**Tillbridge Solar Project  
EN010142**

**Applicant's Response to Examining Authority's  
Third Written Questions**  
Document Reference: EN010142/APP/9.40

**April 2025  
Revision Number: 00**

Location of the Winter Camp of the  
Viking Great Army at Torksey  
(MLI125067)

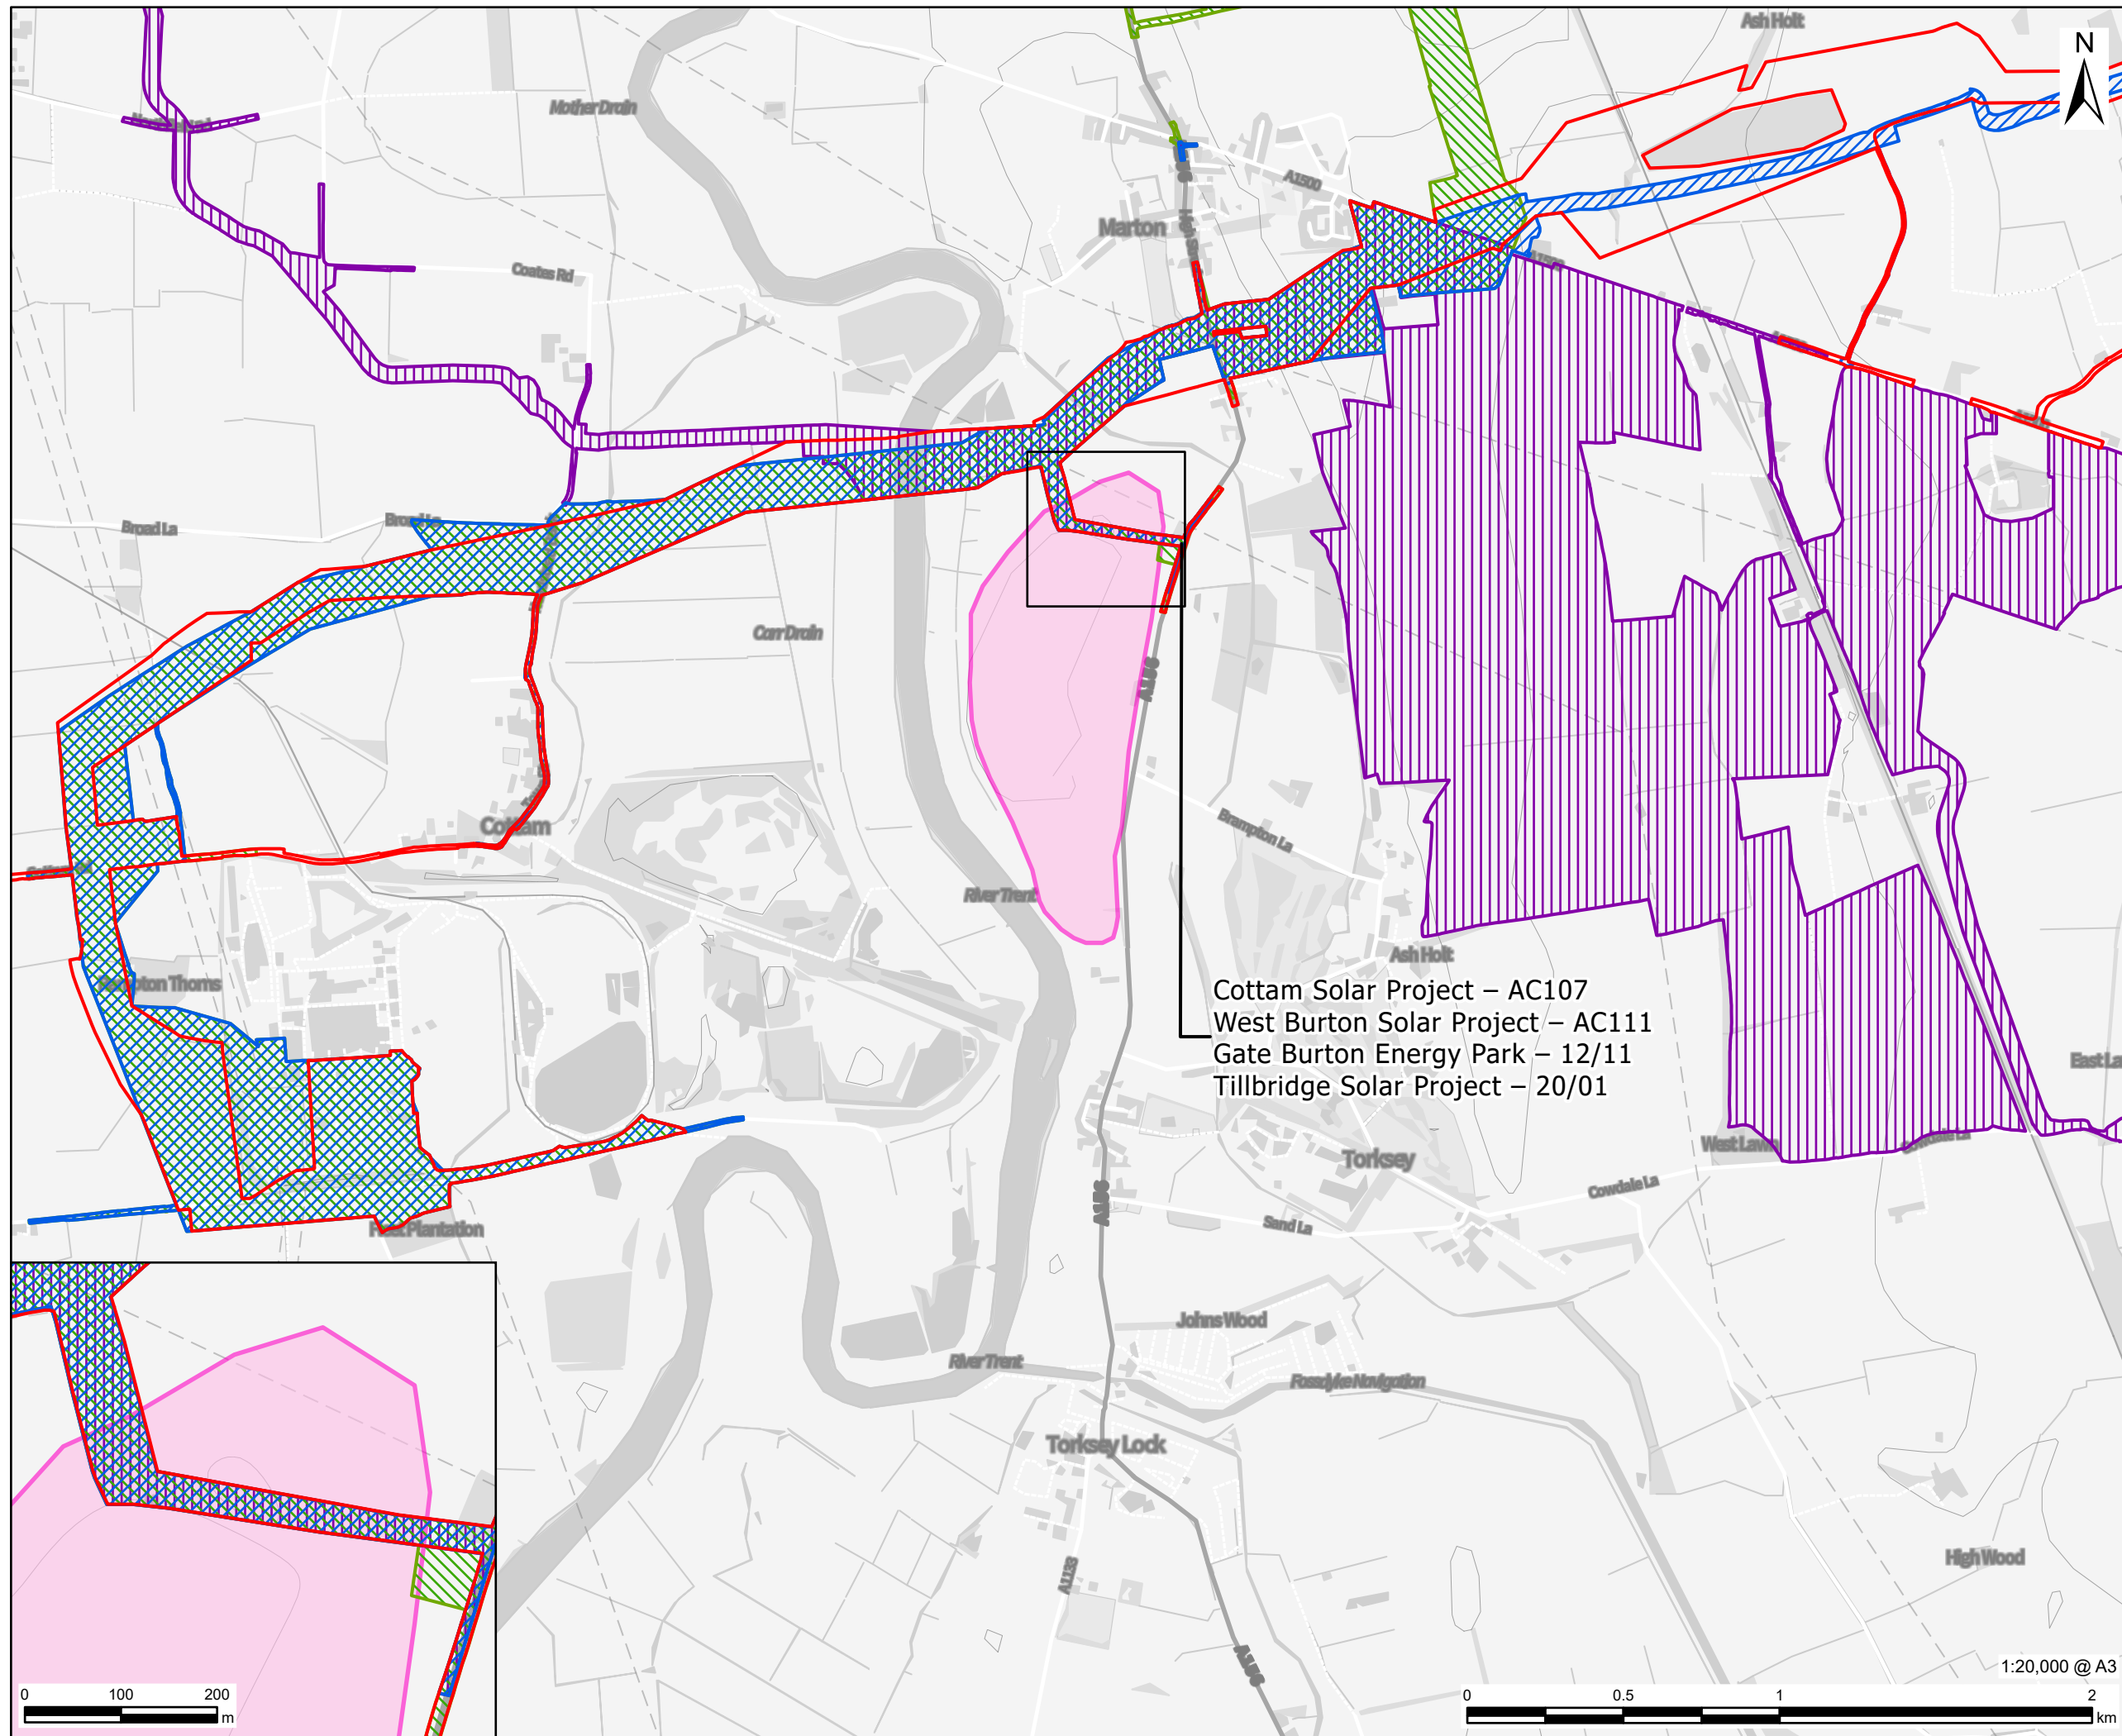
Q3.7.2	Applicant	<p><b>Viking Winter Camp</b></p> <p>The ExA notes the applicant's response to Q2.7.6 [REP5-033] and specifically the references in appendix E, which relate to the extent to which this matter has already been considered in relation to other projects. However, could the applicant please provide a more concise and clear response on the effect of the previously made DCOs on the consideration of this matter. For example, is it the case that the exact same effects would occur in the absence of this project? Is the temporary access location and alignment identical to that consented under other DCOs? Please annotate figure 1 of Appendix E to identify the cable</p>	<p>The Applicant has provided an updated figure within <b>Appendix A</b> of this document.</p> <p>Cable Route Access 6 will be shared by the Scheme and other previously made Solar DCO projects, as shown on the amended Figure 1 in <b>Appendix A</b> of this document. As such, a single access route would be constructed to serve all the projects, resulting one set of construction impacts which would be mitigated by a single coordinated programme of archaeological mitigation measures. Therefore, the same effects would occur in the absence of the Scheme.</p> <p>This approach has been agreed between the Applicant and the other Solar DCO projects, in acknowledgement of the importance and sensitivity of the Winter Camp of the Viking Army at Torksey and to minimise potential harm to the asset.</p>

**Appendix A – Figure to support ExQ3.7.2 response**

Applicants Response to ExQ3.12.2 - Breakdown of land type by area within 5 mile radius of the Principal Site

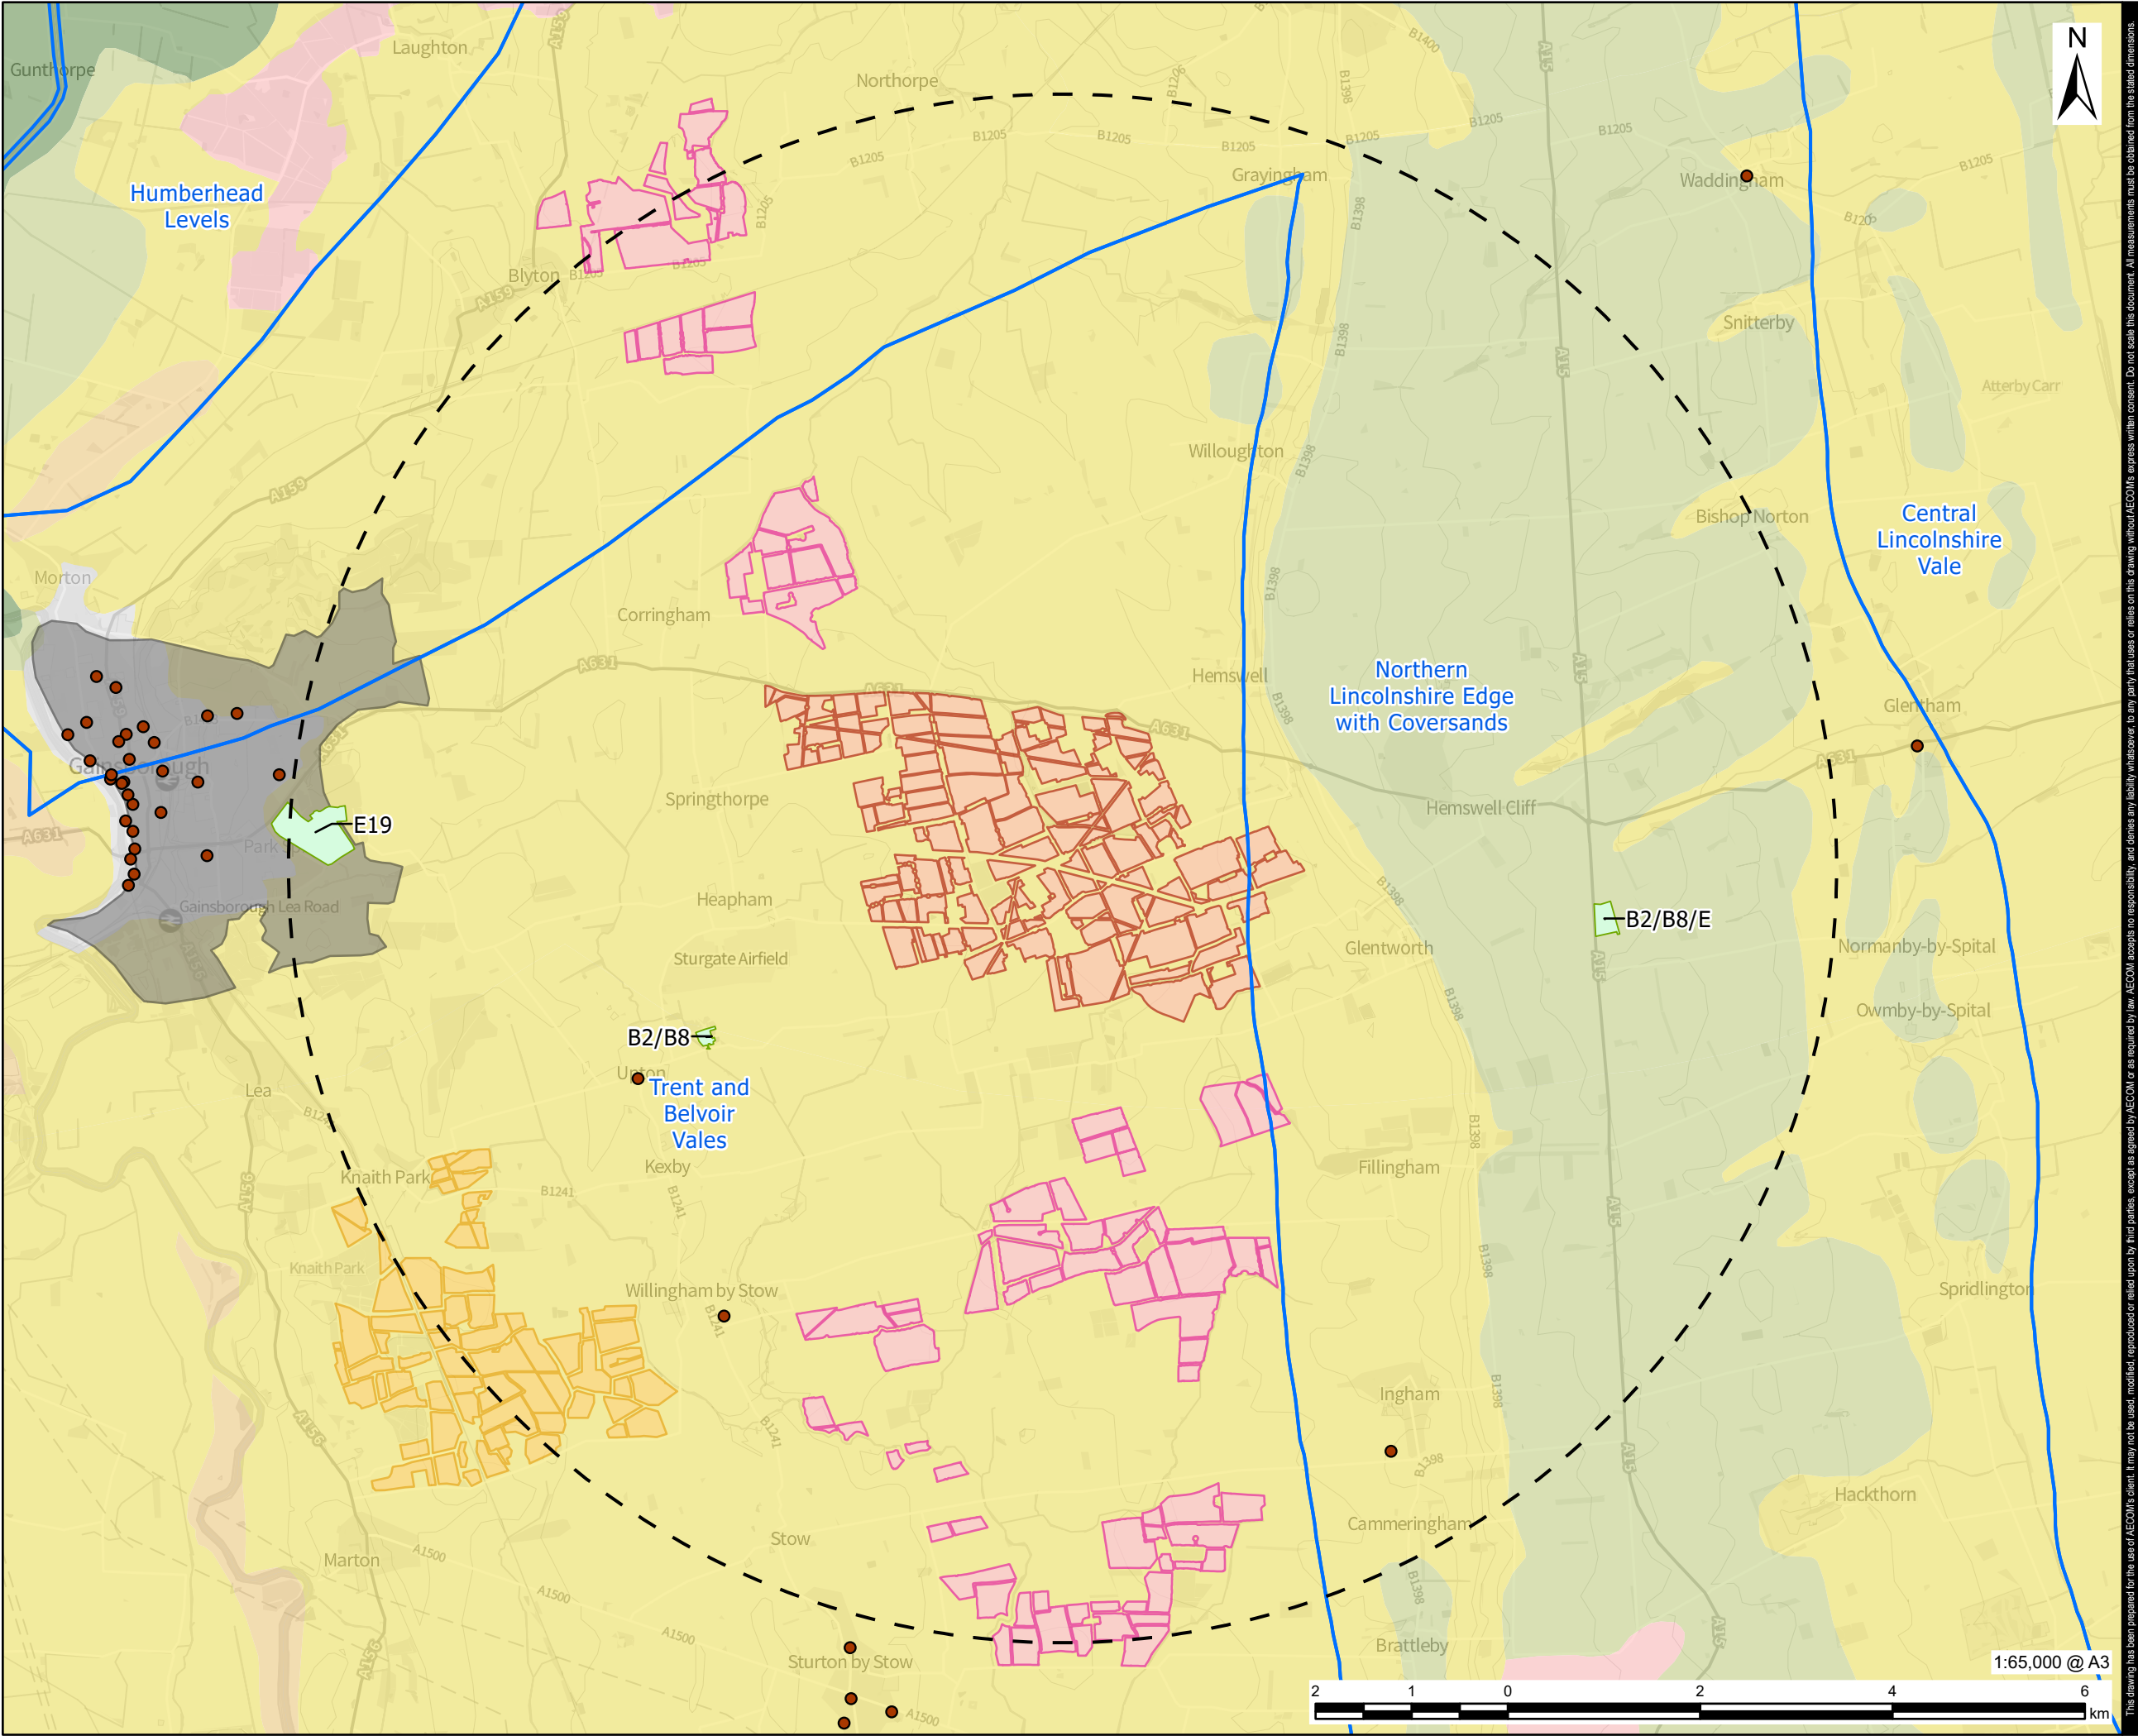
Q3.12.2	Applicant	<p><b>Agricultural Land Classification</b></p> <p>Further to the applicant's response at DL5 the ExA notes the approach taken by the applicant, but would request the applicant provides an additional short summary breakdown of land type by area and mapping to meet the requirements the Governments Written Ministerial Statement "Solar and protecting our Food Security and Best and Most Versatile (BMV) Land" made on 15 May 2024.</p>	<p>The Applicant has provided a response to this question in <b>Appendix B: Breakdown of land type by area within 5 mile radius of the Principal Site</b> of this document.</p> <p>To inform the above, the Applicant reviewed <b>Appendix A</b> of the <b>Applicant's Response to Examining Authorities Second Written Questions [REP5-031]</b> which set out a figure showing the extent of land within a 5 mile radius of the Principal Site broken down into urban, rural and solar land use.</p>

ExQ3	Questions to:	Question:	Applicant's Response:
			<p>The Applicant has also reviewed the Government's Written Ministerial Statement "<i>Solar and protecting our Food Security and Best and Most Versatile (BMV) Land</i>" made on 15 May 2024 (Ref. 9) and notes that it sets out that '<i>applicants should, where possible, utilise suitable previously developed land, brownfield land, contaminated land and industrial land.</i>'</p> <p>The Applicant acknowledges that this is consistent with paragraph 2.10.29 of NPS EN-3 (Ref. 10) which states:</p> <p><i>"While land type should not be a predominating factor in determining the suitability of the site location applicants should, where possible, utilise suitable previously developed land, brownfield land, contaminated land and industrial land."</i></p> <p>The Applicant also directs the ExA to <b>Chapter 4: Alternatives and Design Evolution</b> of the ES [APP-035], which demonstrates that the Applicant considered the suitability of previously developed and brownfield land for the Scheme.</p> <p>To respond further, the Applicant has undertaken a further search of the following land types, and set these out on the updated map at <b>Appendix B</b>, as well as a table summary of the areas and percentages of these land types:</p> <ul style="list-style-type: none"><li>• Urban Land</li><li>• Industrial Land</li><li>• Brownfield Land/Previously Developed Land</li><li>• Contaminated Land</li><li>• Rural Land</li><li>• Area of Solar PV</li></ul> <p>The updated map and table at <b>Appendix B</b> demonstrate the lack of industrial land within a 5-mile radius. These sites are protected within the adopted Central Lincolnshire Local Plan (Ref. 11) as existing employment sites to be retained in such use contributing towards the strategic employment land supply within the District in accordance with Policies S31 (Important Established Employment Areas) and S32 (Local Employment Areas). A change of use from non-employment use would be a departure from the Development Plan. As such, they are not available for alternative uses.</p> <p>There are only three brownfield sites within a 5-mile radius of the Principal Site with a combined area of 2.27 hectares and there is no contaminated land within the search area as defined by Part 2A of the Environmental Protection Act 1990 (Ref. 12).</p> <p>The above, along with <b>Chapter 4: Alternatives and Design Evolution</b> of the ES [APP-035] confirms that the use of agricultural land for the Scheme is justified and necessary. In addition, the site selection process undertaken also confirms that the Applicant sought to utilise land of a poorer agricultural quality before utilising higher quality land through avoiding Grade 2 land as shown on provisional mapping. This is illustrated on the map to <b>Appendix B: Breakdown of land type by area within 5-mile radius of the Principal Site</b> where the Grade 2 land is located to the east of the Principal Site extending in a broad north-south direction.</p>

ExQ3	Questions to:	Question:	Applicant's Response:
			<p>This further demonstrates compliance with the Written Ministerial Statement (Ref. 9) with respect to :</p> <p>“Where the proposed use of any agricultural land has been shown to be necessary, poorer quality land should be preferred to higher quality land avoiding the use of “Best and Most Versatile” agricultural land where possible.”</p> <p>The Applicant has demonstrated throughout the DCO process that the Scheme is located primarily on lower quality agricultural land, with the majority of the Scheme (&gt;95%) being on non-BMV land and has proved that the use of agricultural land is necessary and that poorer quality land has been preferred to higher quality agricultural land thereby being fully in accordance with policy.</p>
